Vehicle Engineering Series

MORRIS·MINI·MOKE

2nd Edition Corrections

Last update 4/10/2024

Fig. 5.1.9 Fuel supply pipes AYK2085.

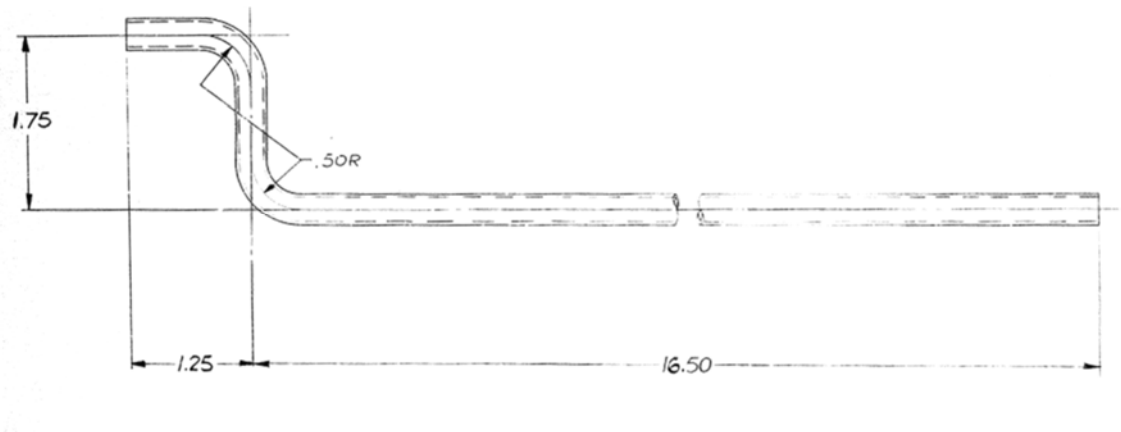
Coated steel Bundy tube ¼" AYK2085 OD supplies fuel from the tank to flexible hose AYA2055 11.5" long, and then AYK2086 flexible hose to pump.
